WOODSIDE SUBDIVISION, UNIT NINE

APPLICATION NUMBER 28 DATE August 16, 2007

DETAIL SITE PLAN

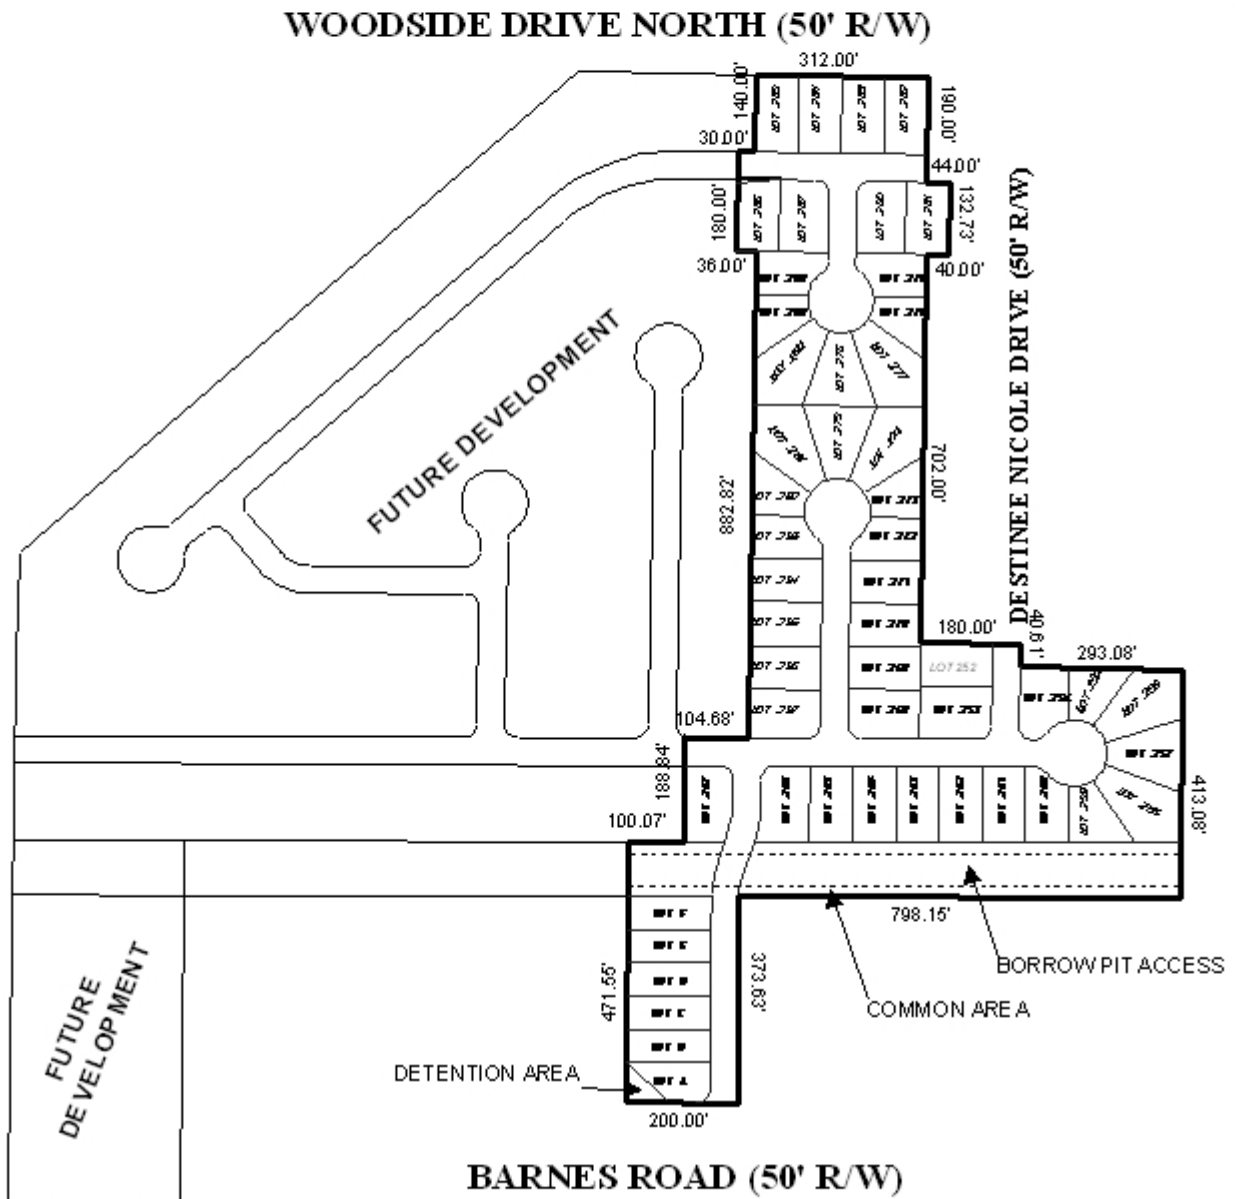
The site extends west from Woodside Drive North, and the southern extension of Destinee Nicole Drive, each of which has a 50' right-of-way. The application involves the creation of new streets, which should be constructed to Mobile County standards and dedicated to Mobile County.

The site abuts a large, undeveloped, landlocked parcel to the East, which is currently used as a borrow pit and is owned by another party; while there is an access easement to the parcel, a street stub to the East should nevertheless be provided, in accordance with Section V.B.1 of the Subdivision Regulations.

The 25-foot minimum building setback line, required in Section V.D.9., is not shown for the subdivision, but would be required on the final plat, if approved.

Common areas and detention areas are shown on the plat; a note should be placed on the final plat stating that maintenance of the common areas and detention areas shall be the responsibility

of the property owners. If additional detention areas are provided in order to comply with the City of Mobile storm water and flood control ordinances, they should also be labeled as common areas.

A note should be placed on the Final Plat stating that any lots which are developed commercially and adjoin residentially developed property must provide a buffer, in compliance with Section V.A.7. of the Subdivision Regulations.

The plat meets the minimum requirements of the Subdivision Regulations and is recommended for Tentative Approval, subject to the following conditions:

- 1) the construction to Mobile County standards and dedication of the new streets to Mobile County;
- 2) the provision of a public street connection to Barnes Road in the first phase of Unit Nine, prior to the recording of any other phase of Unit Nine, or any other future unit;

- 3) the provision of a street stub to the undeveloped parcel to the East;
- 4) the depiction of the 25-foot minimum building setbacks, as required in Section V.D.9. of the Subdivision Regulations;

- 5) the labeling of all common areas, including storm water detention areas, and the placement of a note on the final plat stating that maintenance of common areas shall be the responsibility of the property owners;

- 6) provision of a certification letter from a licensed engineer to the Planning Section of Urban Development, certifying that the storm water detention, drainage facilities, and release rate comply with the City of Mobile storm water and flood control ordinances, prior to the signing and recording of the final plat for each phase;

- 7) revision of the plat to label each lot with its size in square feet, or provision of a table on the plat depicting the same information; and
- 8) placement of a note on the final plat stating that any lots which are developed commercially and adjoin residentially developed property must provide a buffer, in compliance with Section V.A.7. of the Subdivision Regulations.
